TECHNICAL DECISION RRJ0000-OR-470-4950/A

on continued airworthiness of aeroplane RRJ-95
with deactivated EPAS system of entrance/service doors in automatic mode

Fig. 1 (Front passenger door)

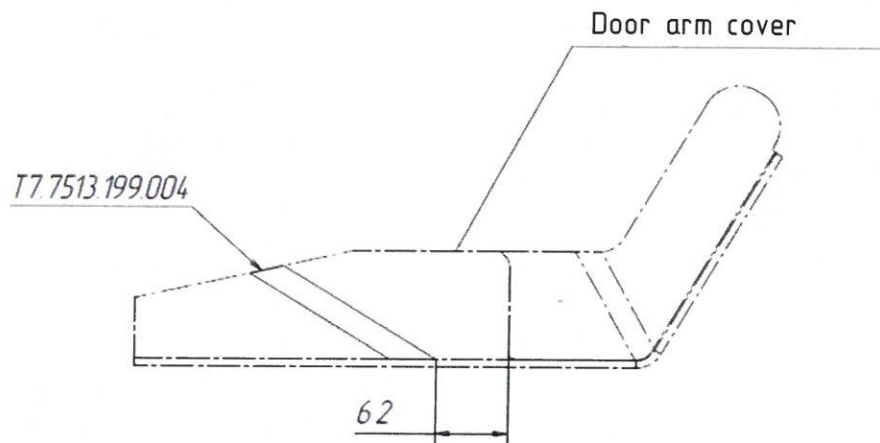
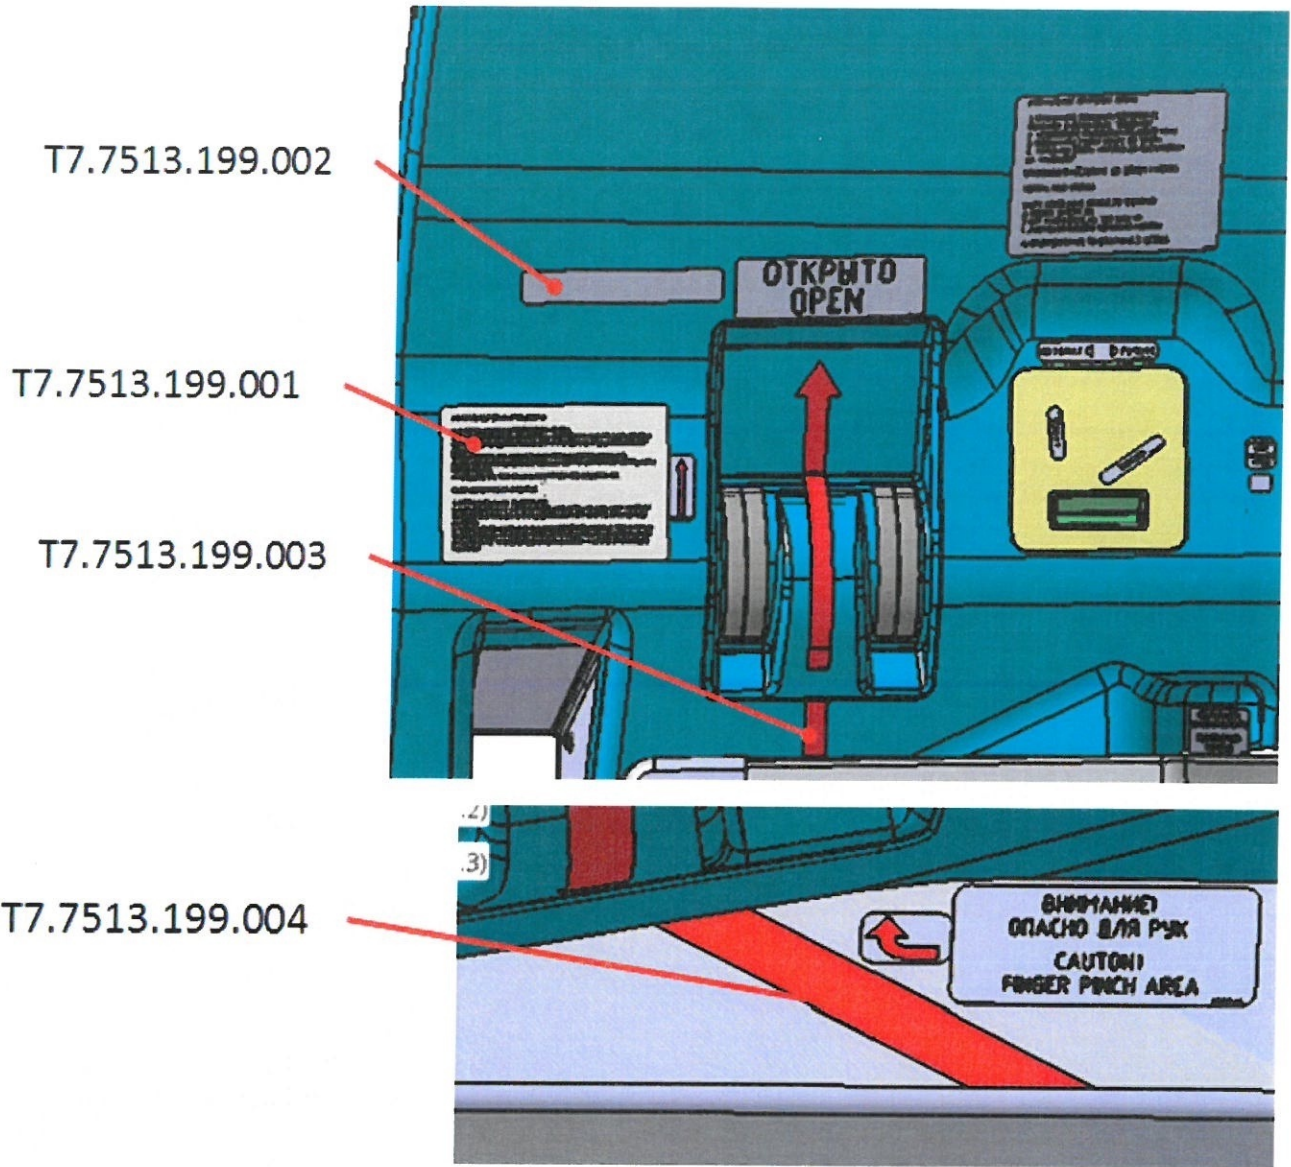
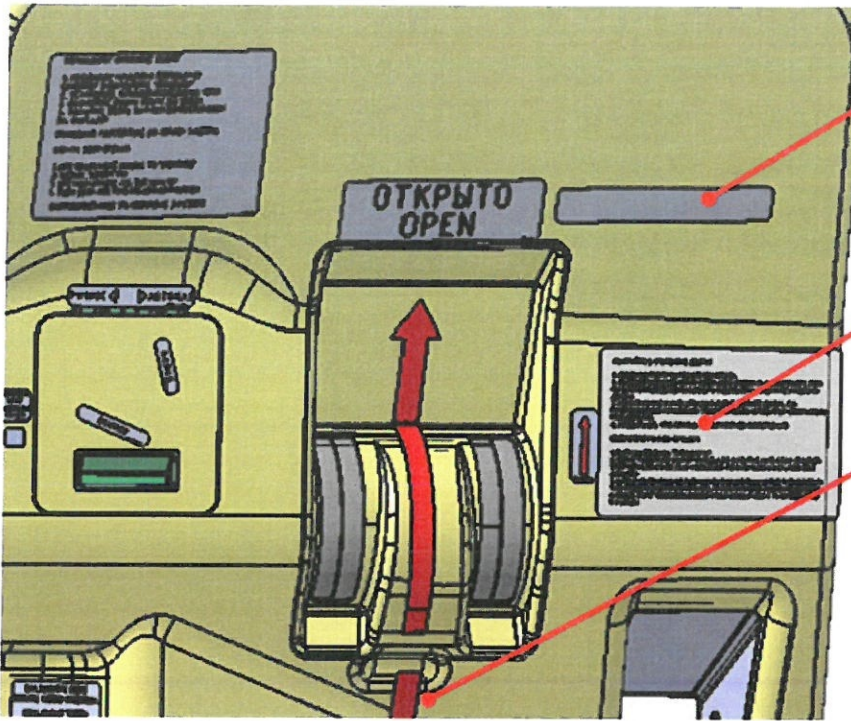
- To install new and shift earlier installed placards: on front passenger door (see Fig.1, Fig.4, Fig.5), on front service door (see Fig.2, Fig.4, Fig.5), on aft passenger and service doors (see Fig.3, Fig.4, Fig.5) in accordance with AMM task 11-00-00-900-801 «Installation and removal of inscriptions».

Fig. 4 Placards

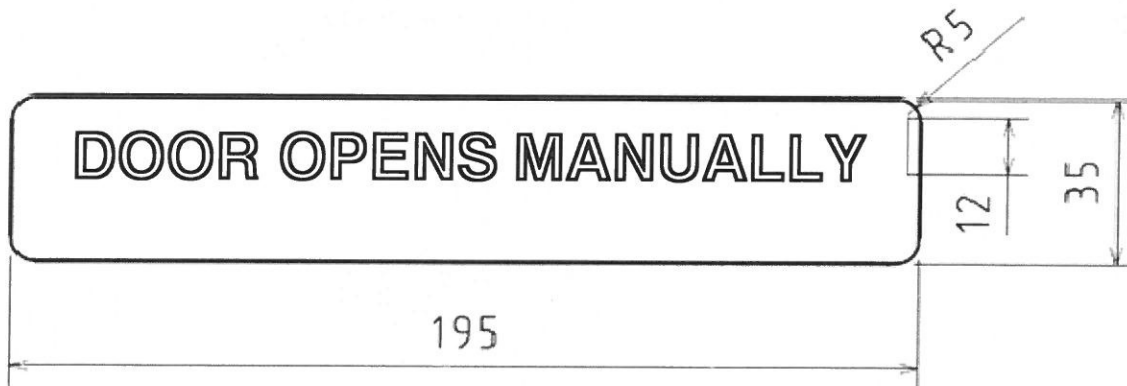
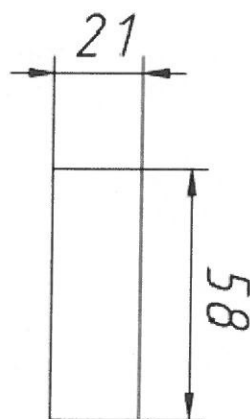
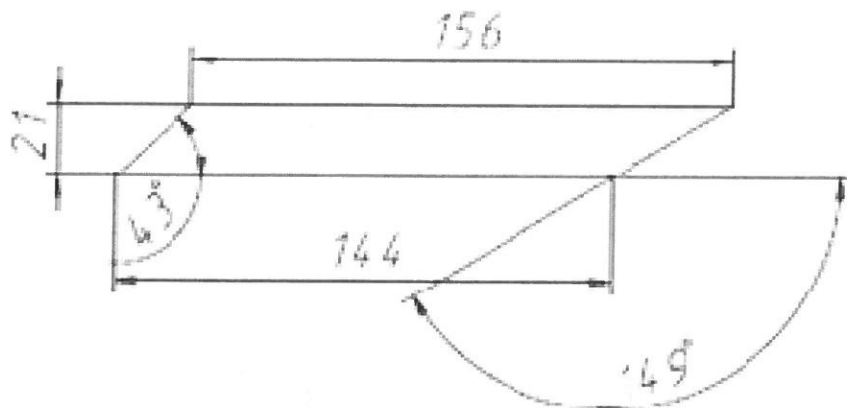
The installation of the placard p/n T7.7513.199.002 «DOOR OPENS MANUALLY» is mandatory requirement of Airworthiness Directive №2020-FATA-01020A-04.

4. After SB implementation RRJ-52-00485-БД to remove placards p/n T7.7513.199.001, T7.7513.199.002 (see Fig. 4) installed in accordance with Technical Decision RRJ0000-OR-470-4950/A: on front passenger doors (see Fig. 1, Fig. 4), front service door (see Fig. 2, Fig. 4), on rear passenger and service doors (see Fig. 3, Fig. 4) in accordance with AMM task 11-00-00-900-801 «Installation and removal of inscription».
